CENTREVILLE PLANNING COMMISSION

**RE: Site Plan Planning Commission Submittal #2 – Tred Avon Partners, LLC
216 N Commerce St Mixed-Use Building**

**RE: Variance Application – Tred Avon Partners, LLC
216 N Commerce St Mixed-Use Building**

Re: Final Site Plan Review and Variance
Request 216 N Commerce Street - Mixed Use
Building

EXHIBIT SHOWING LOTS WITH
DRIVEWAYS CLOSER THAN 7.5' TO
THE SIDE PROPERTY LINE
(ANNOTATIONS DRAWN ON TOP OF THE
NOT-TO-SCALE CENTREVILLE ZONING MAP)
4/3/2024

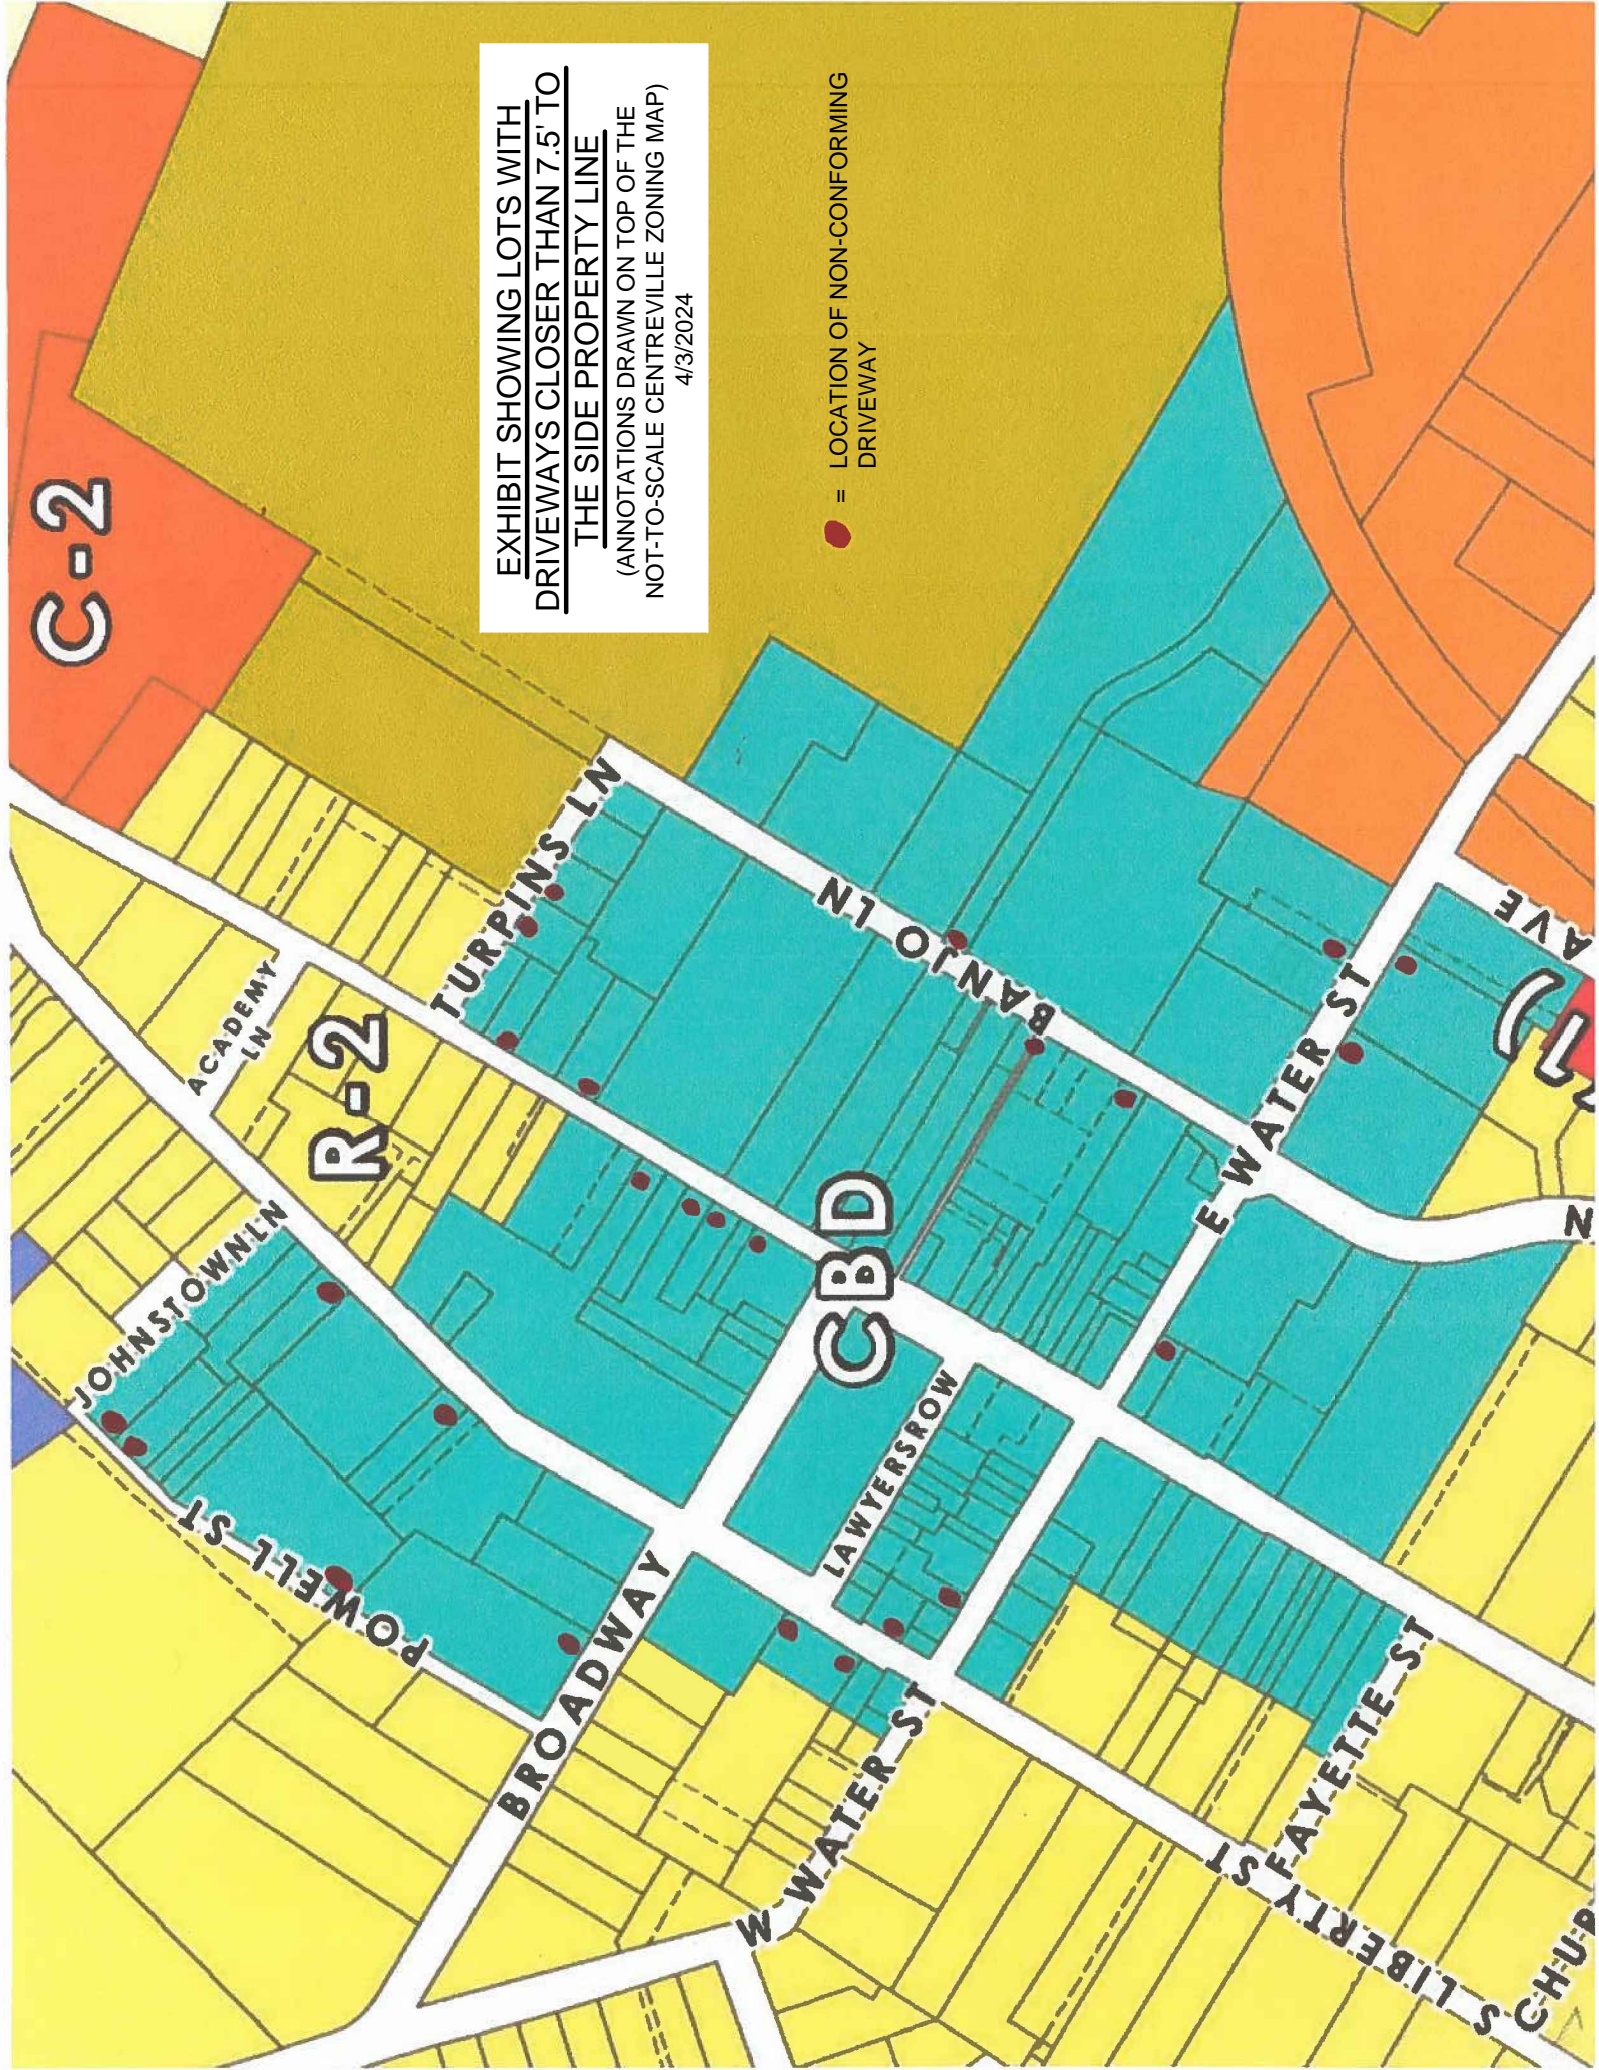
In addition, we would like to note that this requirement is not met by approximately 25 existing properties/sites within the CBD zone as marked on the attached annotated zoning map. For this reason, we do not believe that granting the variance will give the applicant a benefit that is more advantageous than any existing property in the downtown area. We would also like to note that the Town Planner has indicated unofficially that the 7.5' separation requirement is not appropriate in the CBD zone and recommends that the code be revised.

PLOTTED: Apr 03, 2024 - 7:19am D:\My Documents\Dumb Home\Projects\2023\23-013 Trd Avon\CAD\23-013 Site Plan.dwgTab:03SP

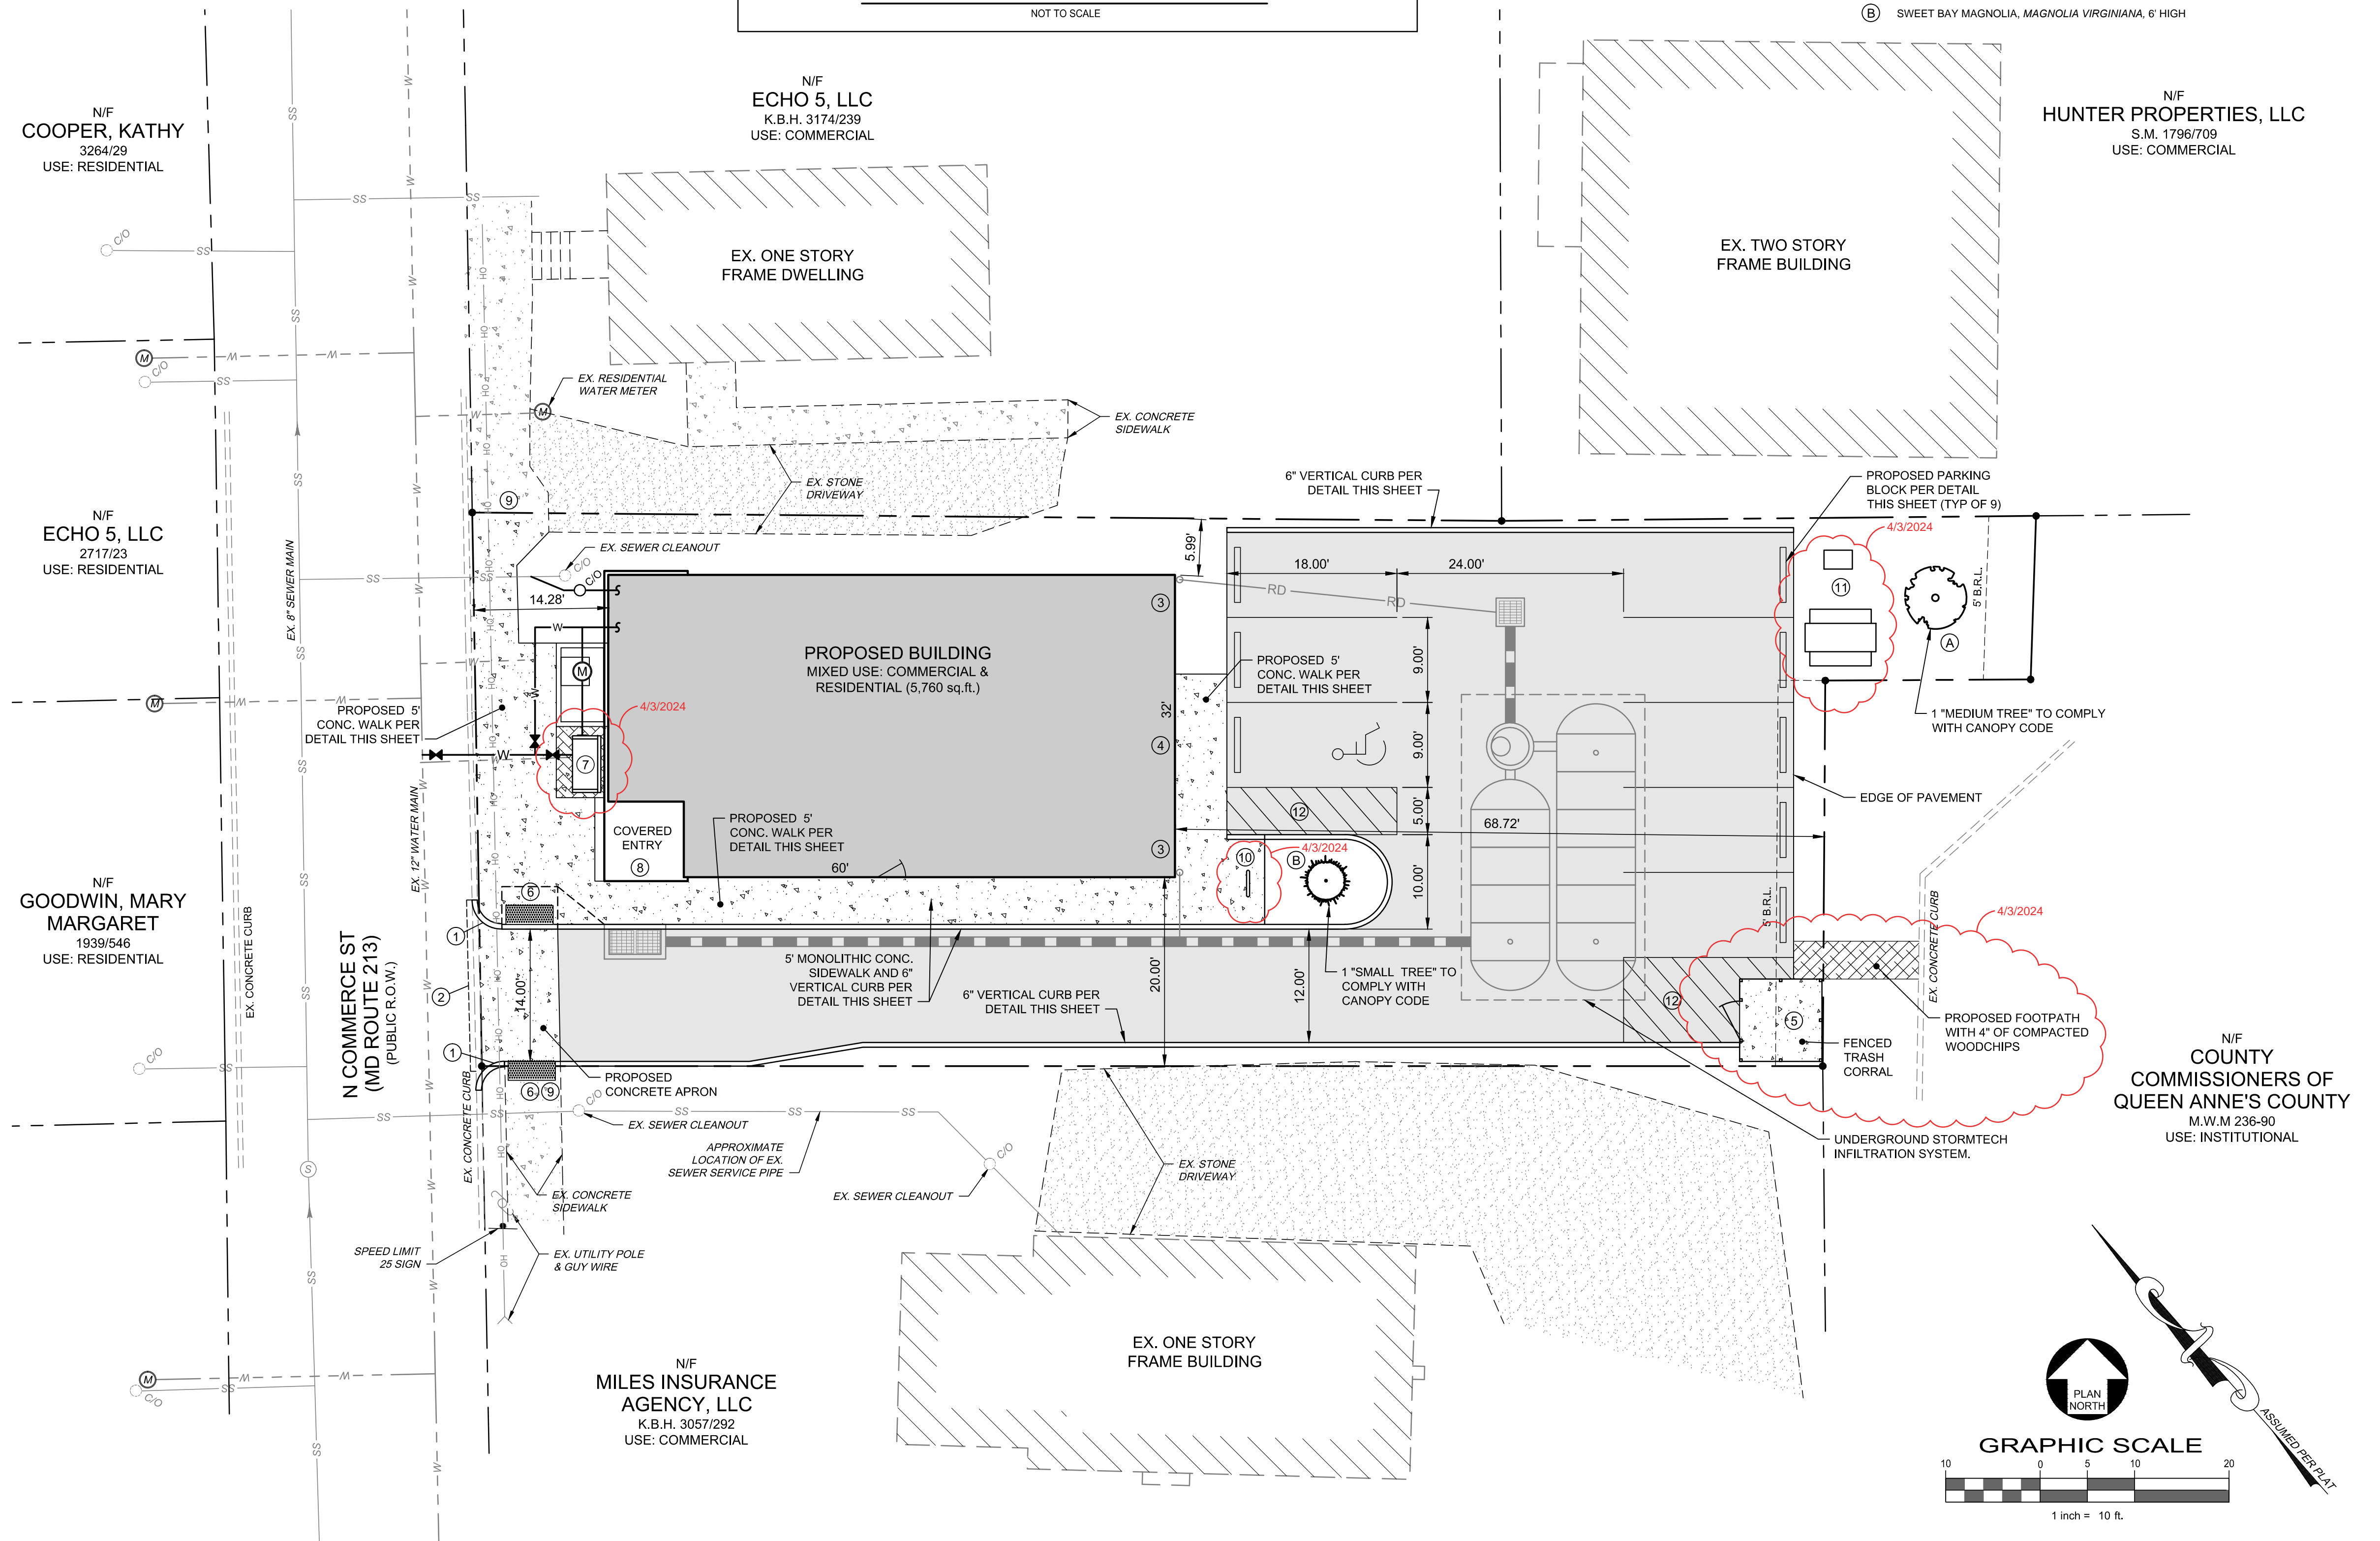
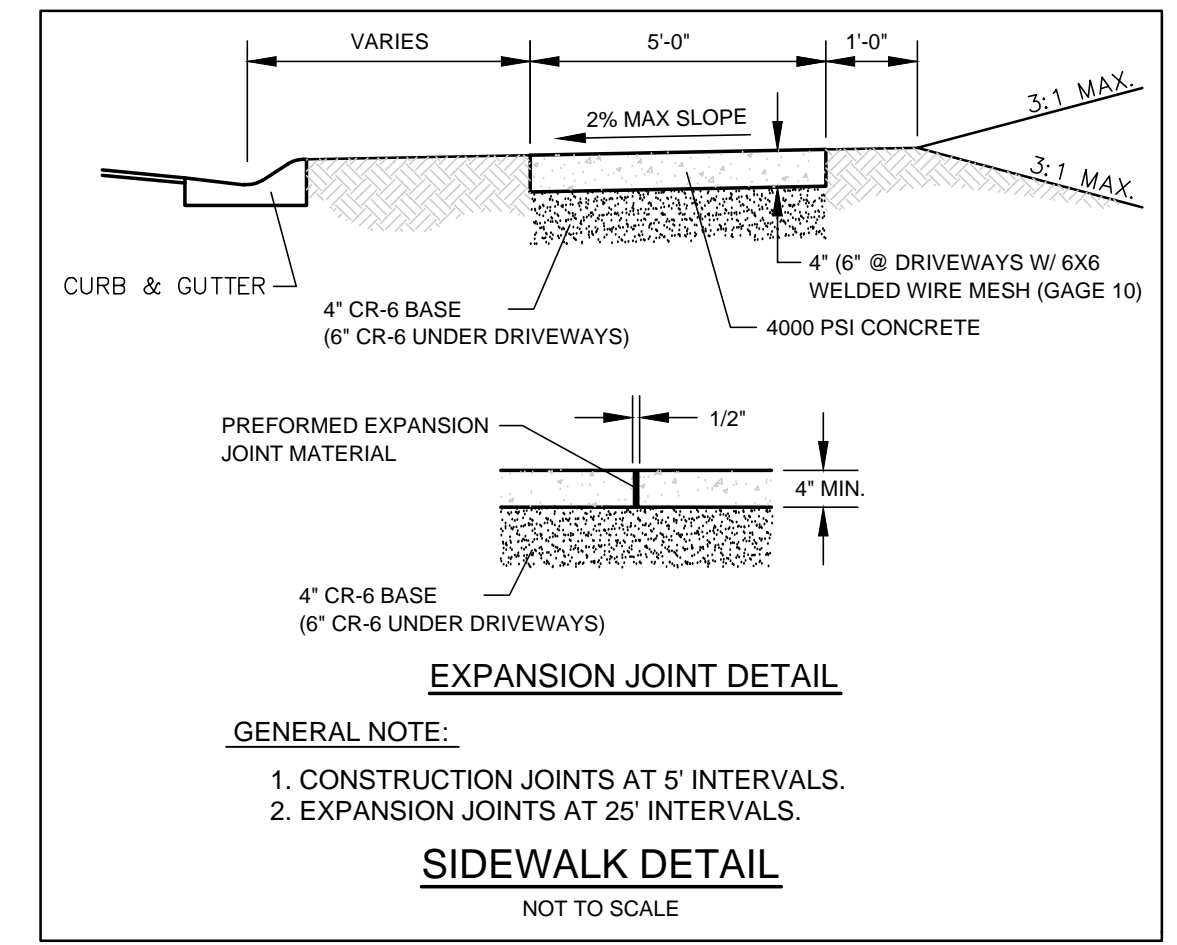
As noted on the application form, the purpose for this application is that the Centreville Zoning Code 170-32 C.2.d. requires driveway entrances to be located at least 7 1/2 feet from side lot lines. We are requesting a reduction so that the face of curb is 0.5' from the right-side lot line. This is necessary to provide width for the required 14' wide entrance driveway and still leave room for a commercially viable building, as well as the existing driveway encroachment on the left side of the lot.

In support of our request, we ask that you keep in mind that the property is zoned Central Business District (CBD). Please review the Sheet 3 site plan and observe the entrance driveway configuration, building size & layout, and the driveway encroachment on the left (north) side from the Echo 5 LLC property. We believe it is obvious that it is not possible to develop the 59' wide lot in a way that is typical of existing lots within the CBD district while still complying with 7.5' separation requirement.

Sheet 3: Key notes and item updates include:

WEST ELEVATION

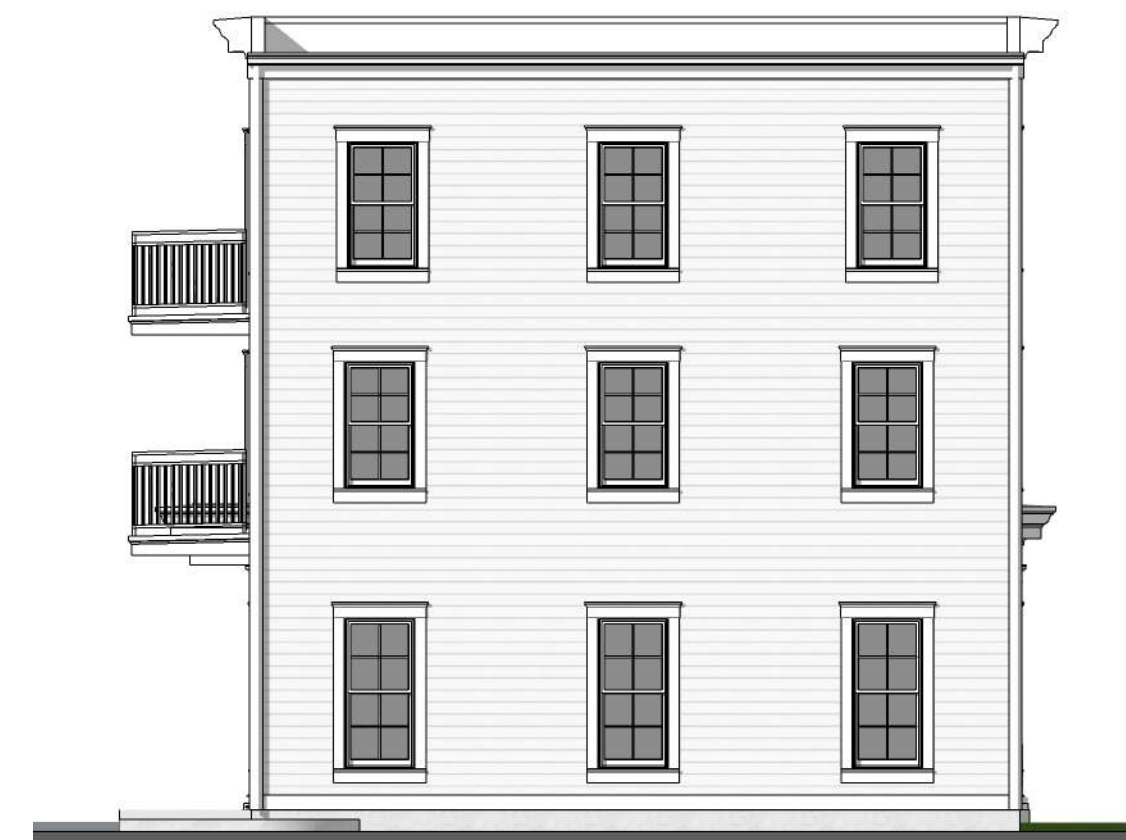
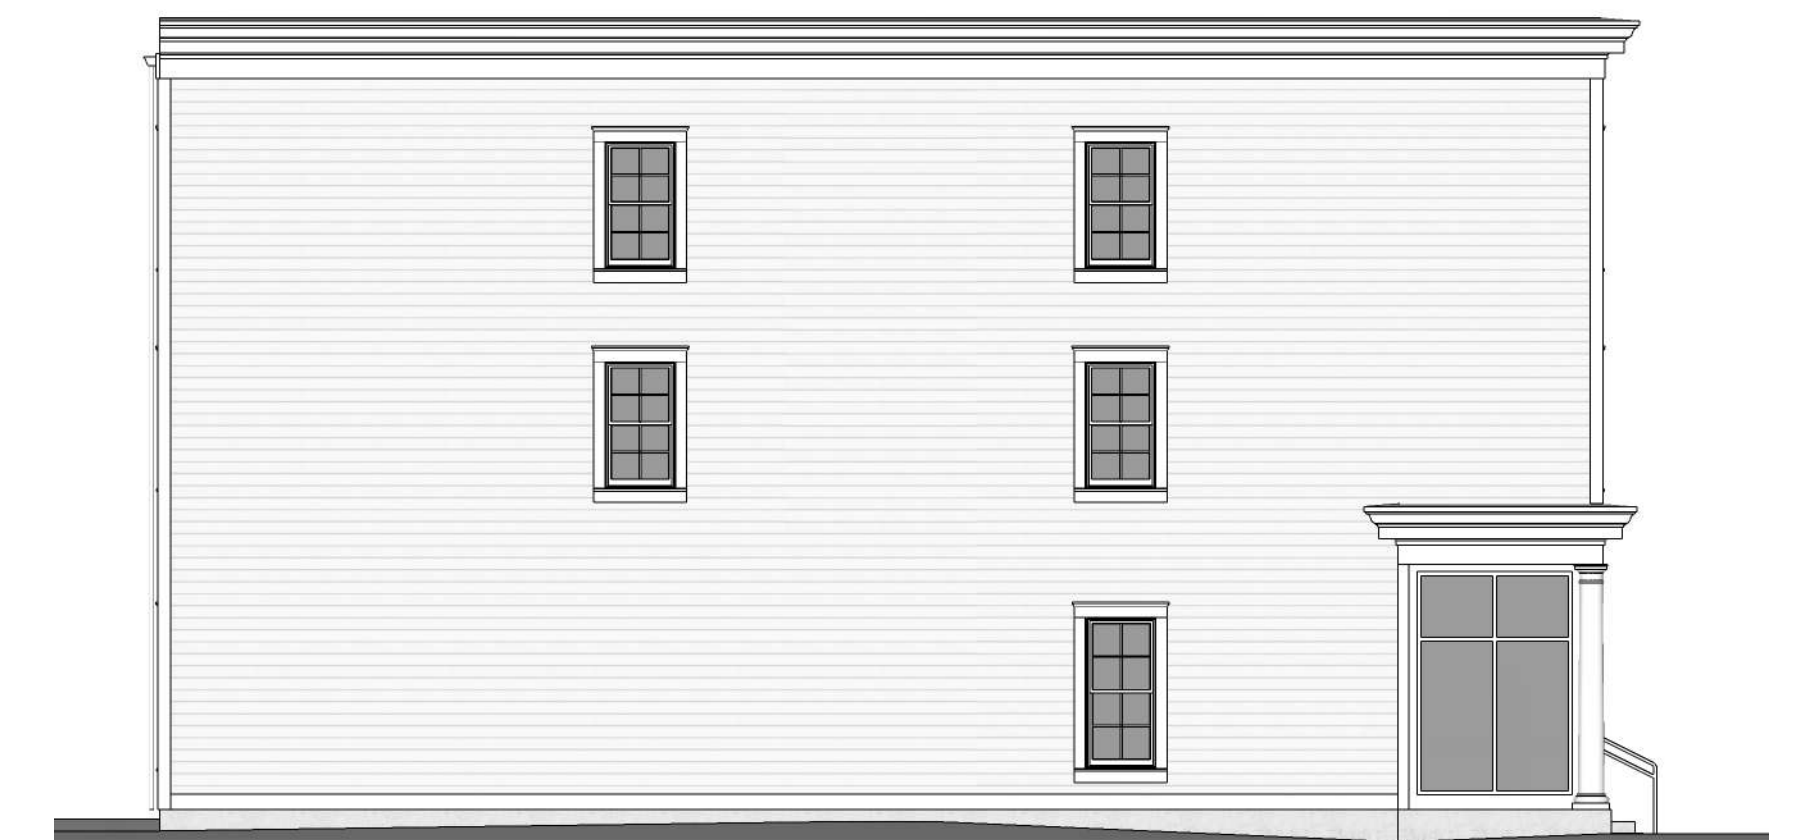
The architectural plans have been updated to note the building height of 33 feet -11 3/4 inches on West Elevation lower left (Schematic Design – sheet 01) as well as proposed floor plan layouts (Schematic Design – Sheet 02).
